【Additional approval and change approval document】

SiC 6-inch factory additional approval
SiC TO-247-4L RIST factory additional approval

Document ID:2222001_PCN Details

PCN No.2222001

5-2.List of changes

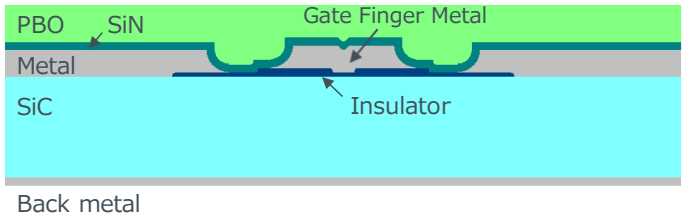
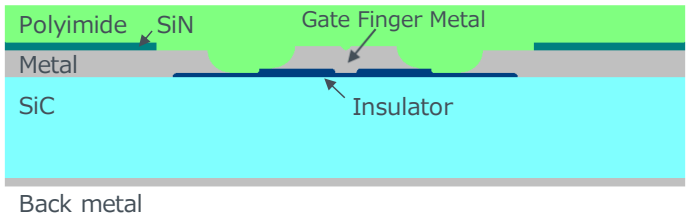
Item	Current products	New products	Purpose of change
Factory	ROHM Apollo co., ltd. (Chikugo)	LAPIS Semiconductor Co., Ltd. (Miyazaki)	improve productivity
Wafer size	4inch	6inch	improve productivity
Back side metal	Ti-Ni(0.6μm)-Au-Ag Ti-Ni(1.2μm)-Au-Ag	Ti-Ni(1.2μm)-Au	improve productivity
Passivation	Polybenzoxazole (PBO)	Polyimide (PI)	improve productivity
Passivation structure of outer peripheral area (red frame below)

improve against passivation cracks due to thermal stress

For 6inch products ,the back metal composition and passivation structure will change.

6-6. Product appearance comparison : Frame

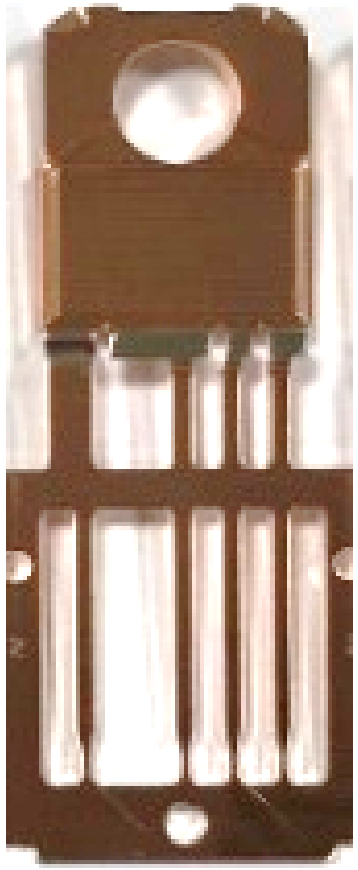
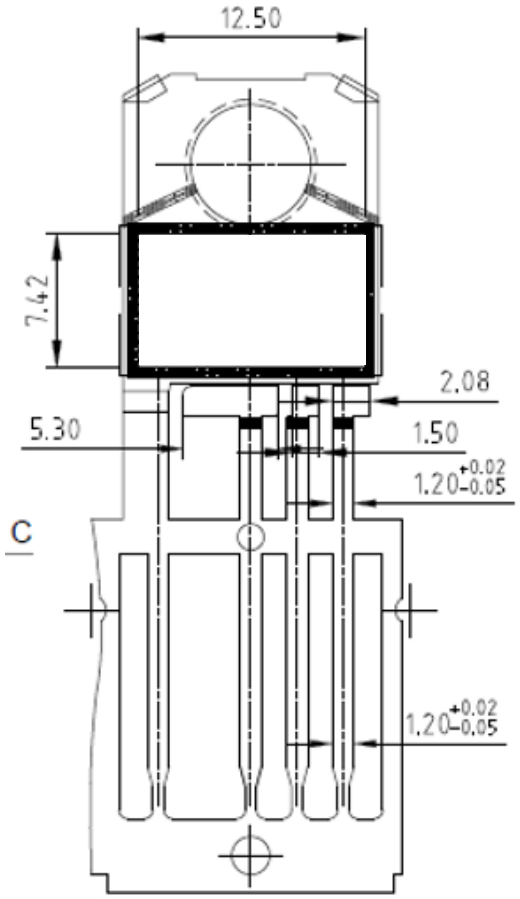
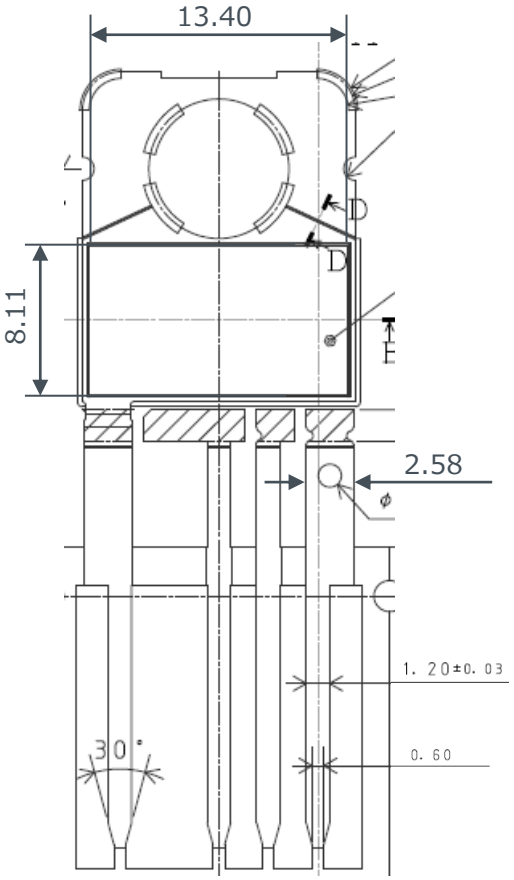
The frame dimensions and shape will change.

6-6. Product appearance comparison : Marking

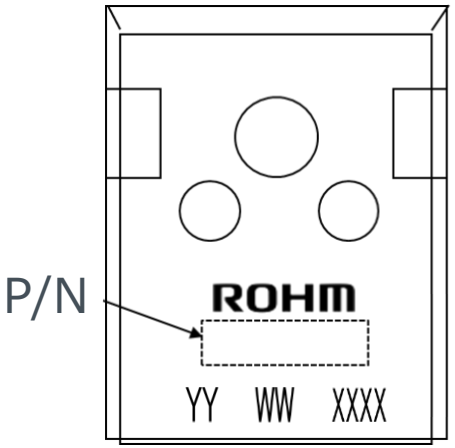
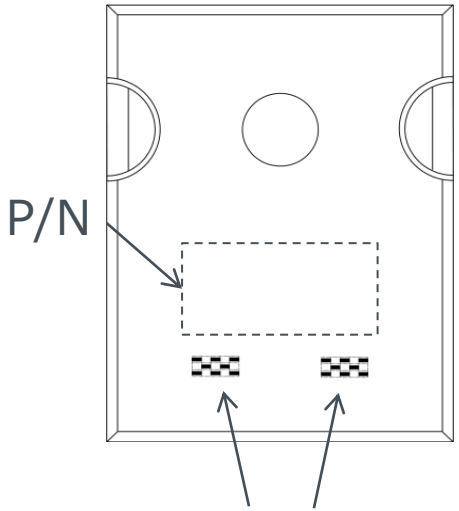
current products (ATX)	new products (RIST)
Marking	P/N Production year Production week LOT ID	P/N Production year(Dot Marking) Production week(Dot Marking) LOT ID(Dot Marking)
Visual

The marking contents will change.

6-6. Product appearance comparison : Tube

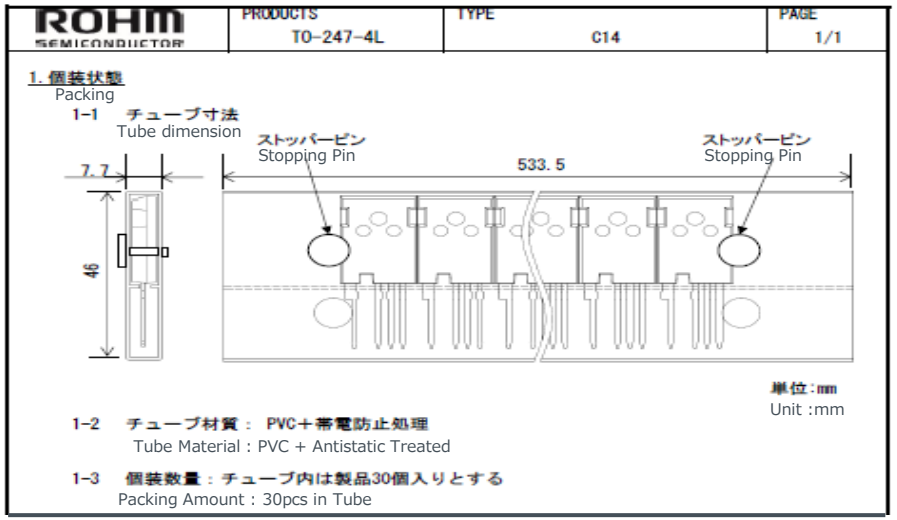
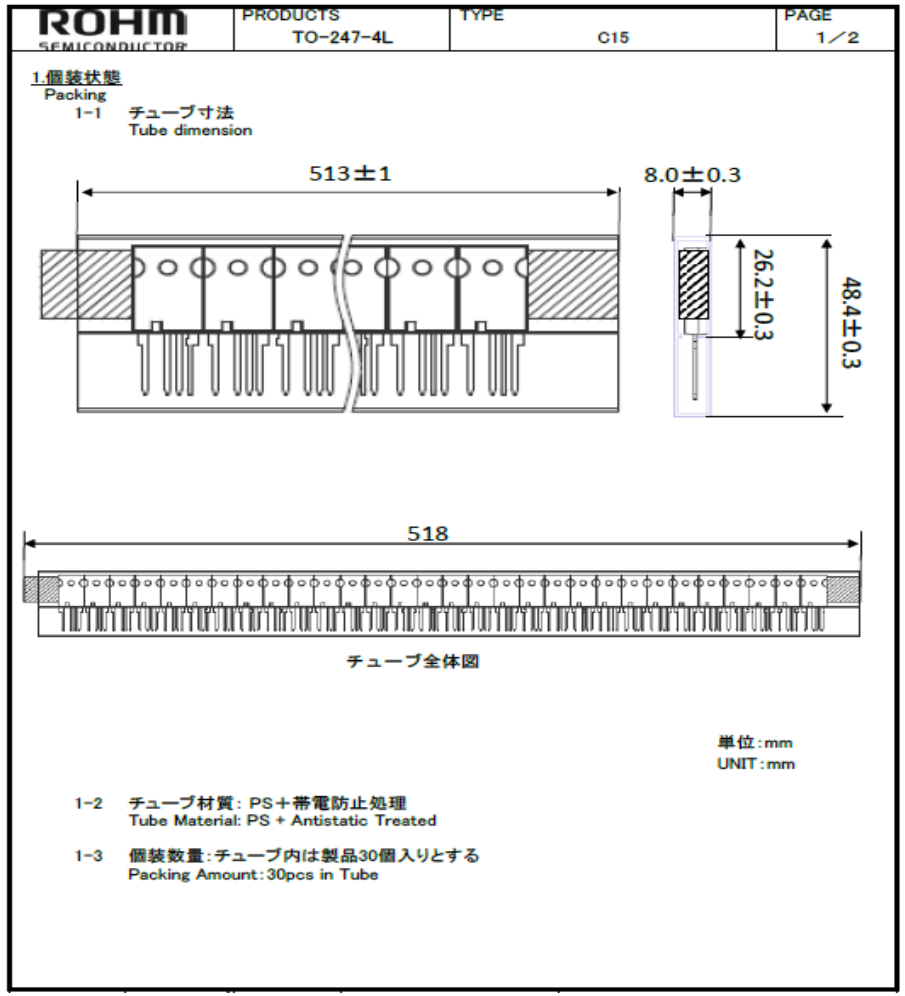
The dimensions, material, and ejection method will change.
Please check if there are any problems with your process.

6-6. Product appearance comparison : Inner box, Outer box

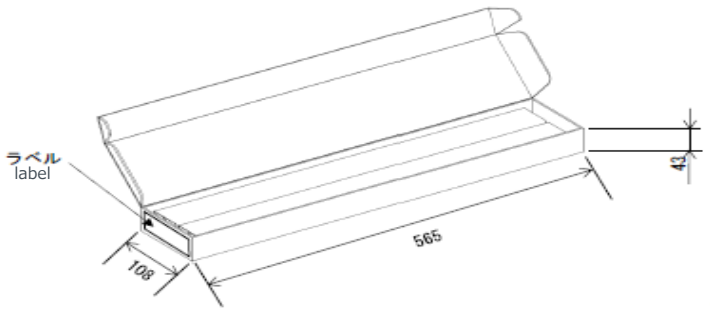
The dimensions of the inner box will change.

6-6. Product appearance comparison : Package Dimensions(Marking side)

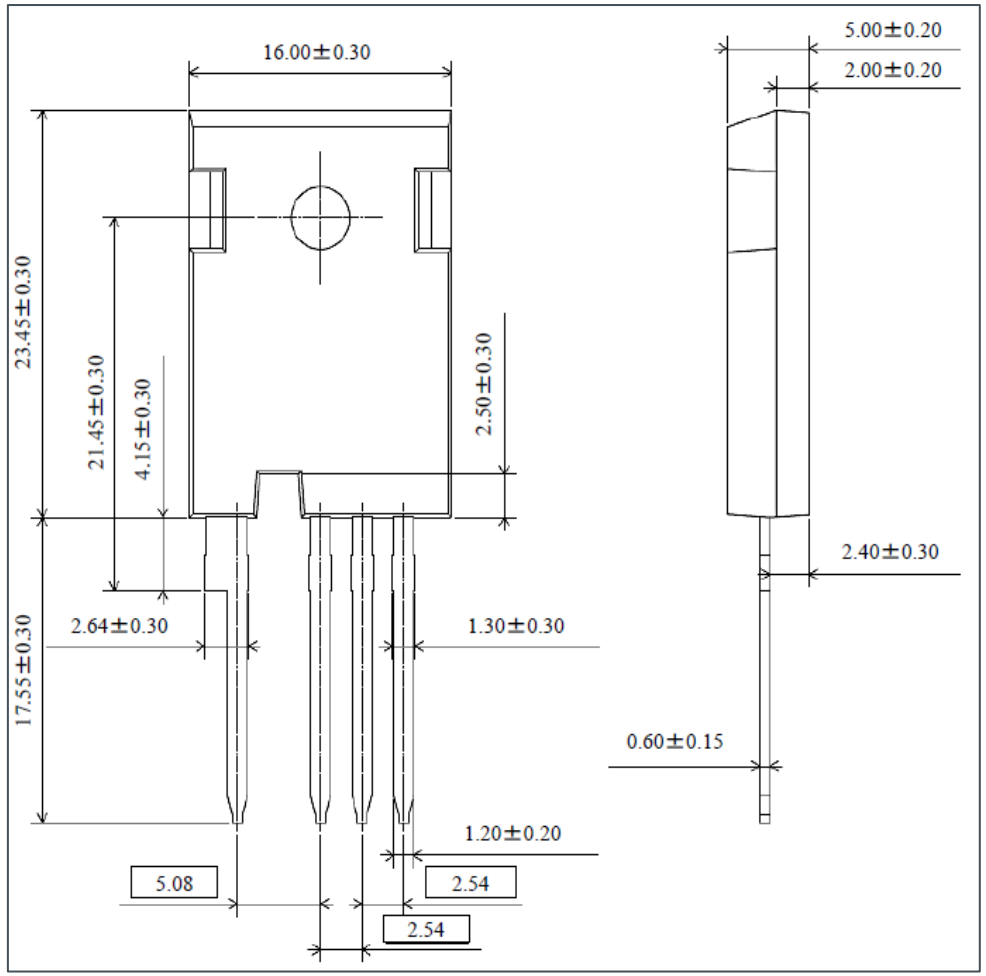
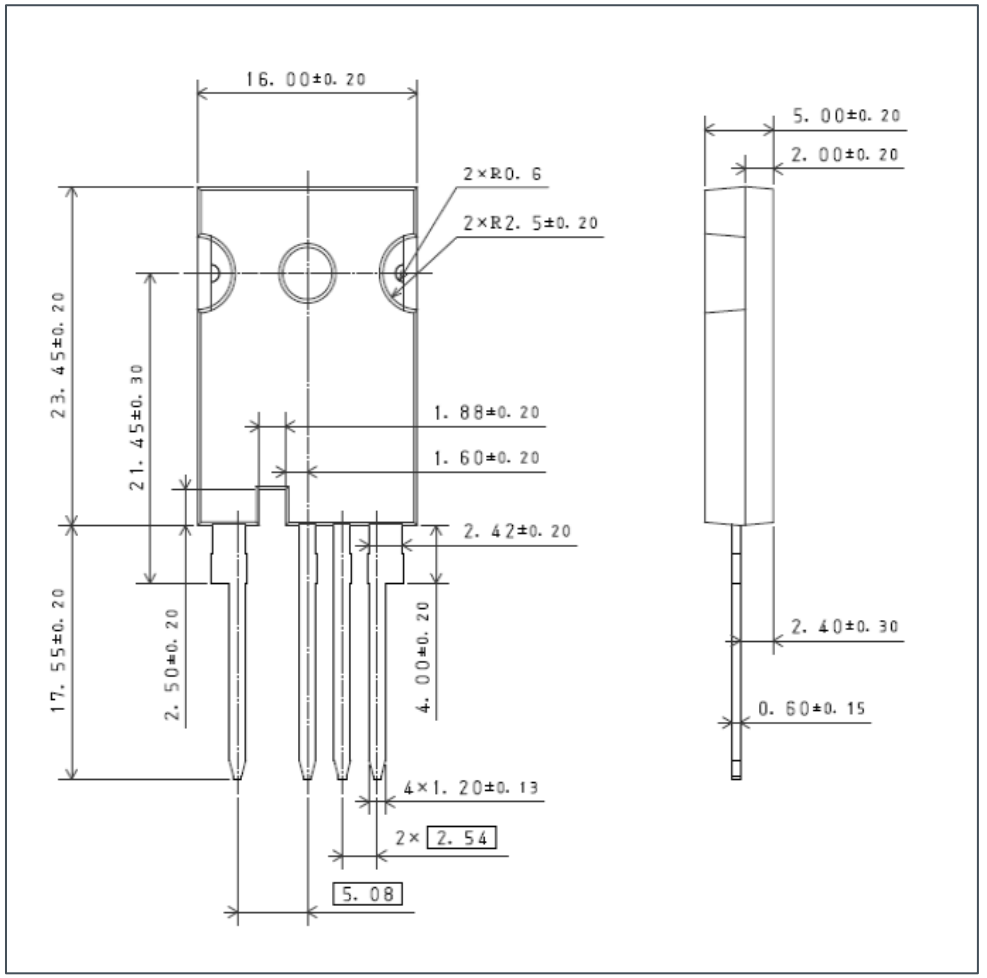
Item	Current products	New products
Factory (Assembly)	ATX*1	RIST*2
Marking	There are changes.	
Tube	There are changes.	
Inner box	There are changes.	
Package dimensions	There are minor changes.

6-6. Product appearance comparison : Package Dimensions Comparison

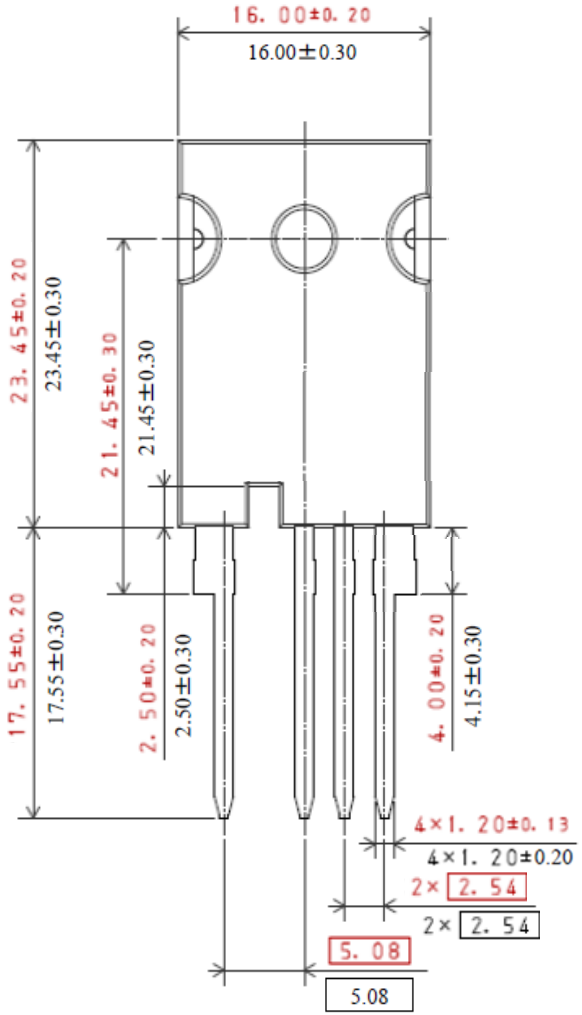
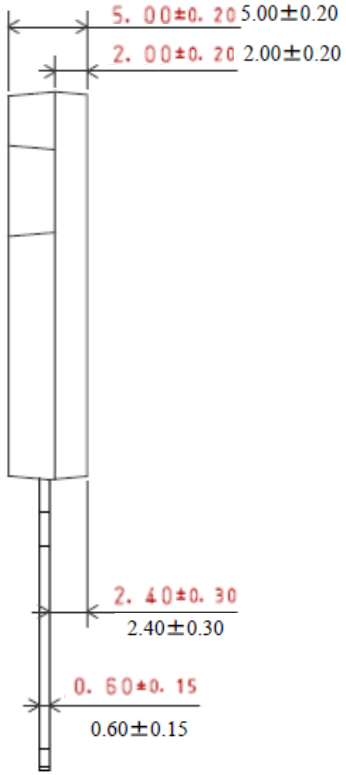
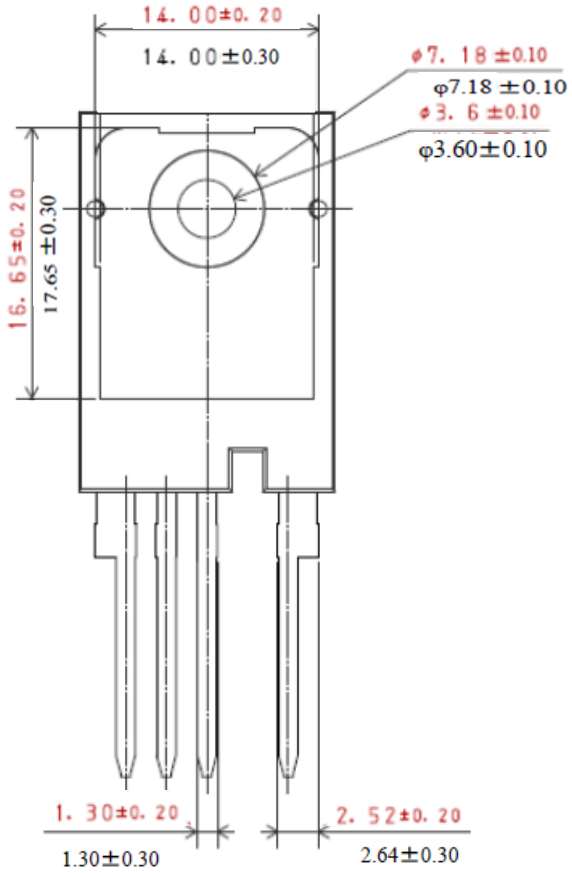
Black :current products (ATX)
Red :new products (RIST)

6-6. Product appearance comparison : Package width

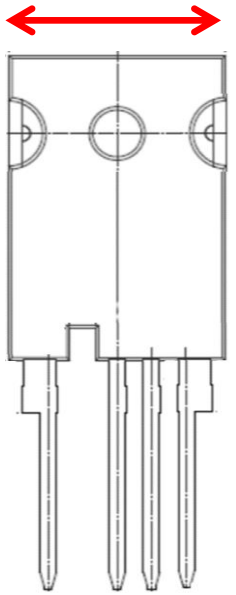
Min	Typ	Max
Current product(ATX)'s standards	15.70	16.00	16.30
New product(RIST)'s standards	15.80	16.00	16.20
difference	+0.10	±0	-0.10

Concern	Nothing.
ROHM comment	With the change to RIST products, the dimensional tolerance becomes smaller and the quality improves.

6-6. Product appearance comparison : Package Height

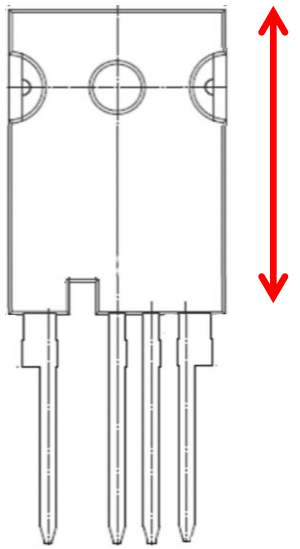
Min	Typ	Max
Current product(ATX)'s standards	23.15	23.45	23.75
New product(RIST)'s standards	23.25	23.45	23.65
difference	+0.10	±0	-0.10

Concern	Nothing.
ROHM comment	With the change to RIST products, the dimensional tolerance becomes smaller and the quality improves.

6-6. Product appearance comparison : Stopper length

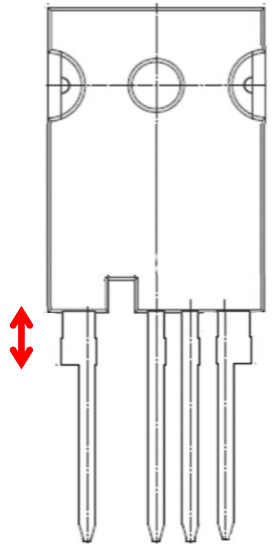
Min	Typ	Max
Current product(ATX)'s standards	3.85	4.15	4.45
New product(RIST)'s standards	3.80	4.00	4.20
difference	-0.05	-0.15	-0.25

Concern	There is a concern that it will not be possible to mount due to the shortening of the stopper length.
ROHM comment	Please check whether there is any problem with the mounting.

6-6. Product appearance comparison : Stopper width

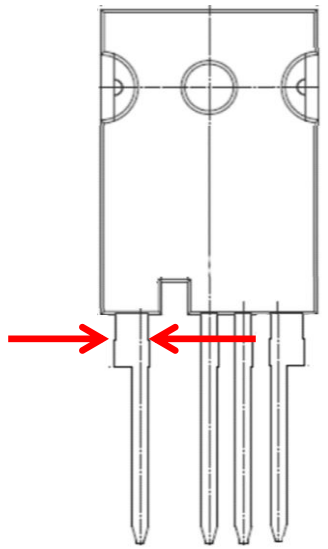
Min	Typ	Max
Current product(ATX)'s standards	2.34	2.64	2.94
New product(RIST)'s standards	2.32	2.52	2.72
difference	-0.02	-0.12	-0.22

Concern	There is a concern that it will not be possible to mount due to the shortening of the stopper width.
ROHM comment	Please check whether there is any problem with the mounting.

6-6. Product appearance comparison : Lead length

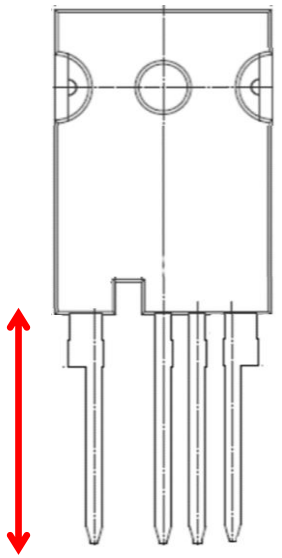
Min	Typ	Max
Current product(ATX)'s standards	17.25	17.55	17.85
New product(RIST)'s standards	17.35	17.55	17.75
difference	+0.10	±0	-0.10

Concern	Nothing.
ROHM comment	With the change to RIST products, the dimensional tolerance becomes smaller and the quality improves.

■ Cross sectional observation of Non-defective samples after TC 1000cyc

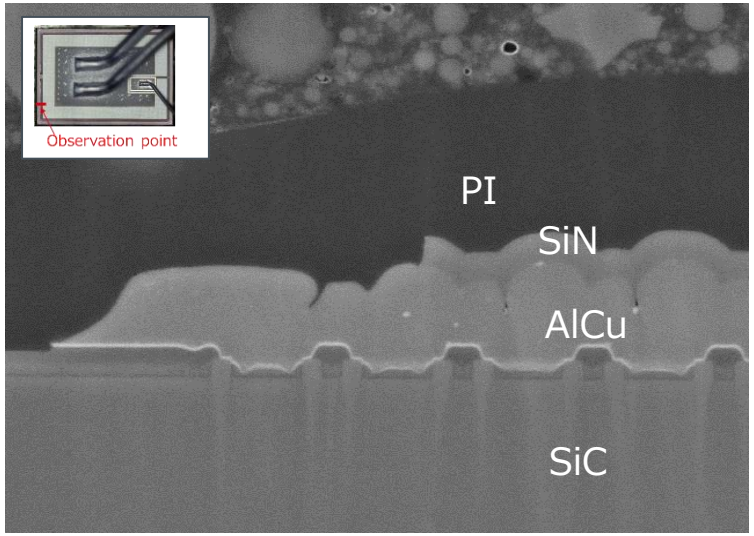
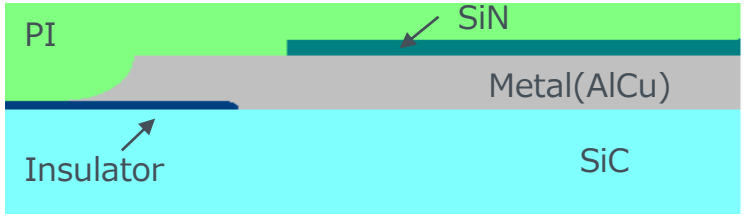
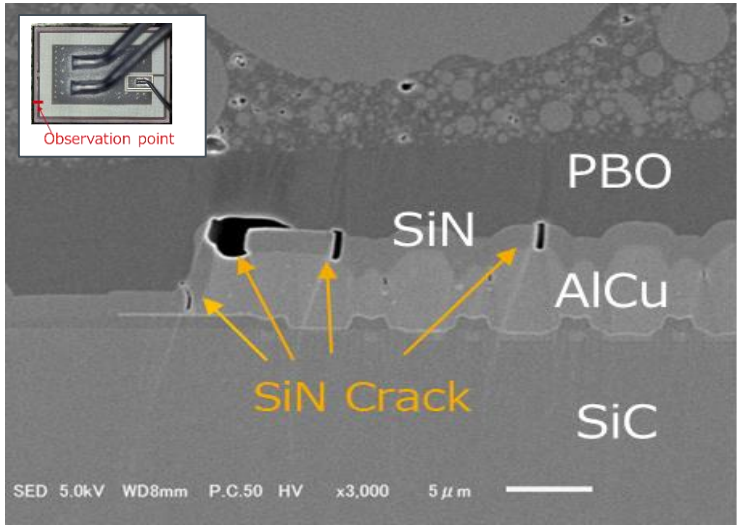
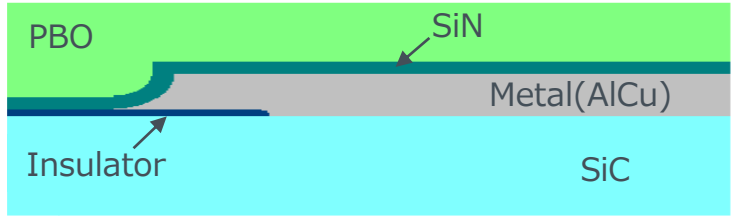
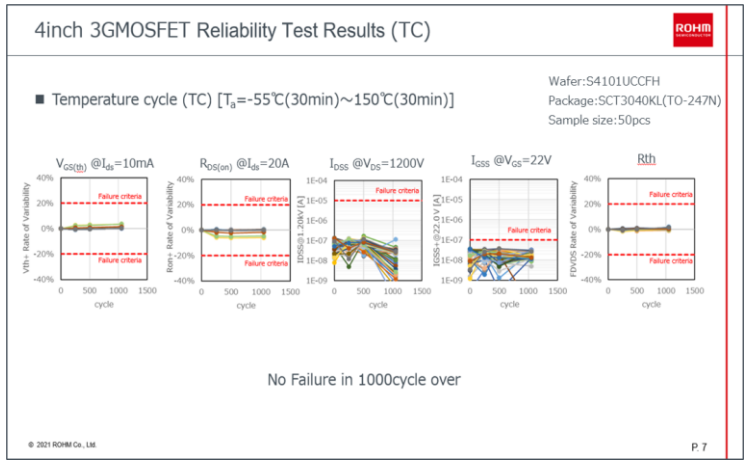
In 4inch 3GMOSFET, SiN layer in outer peripheral area may be cracked due to thermal stress such as temperature cycles. However, at the time of the TC 1050 cycle, the cracks are minor and there are no changes in characteristics, so there is no problem.

Structural changes have improved robustness against the cracking of the passivation layer(SiN).
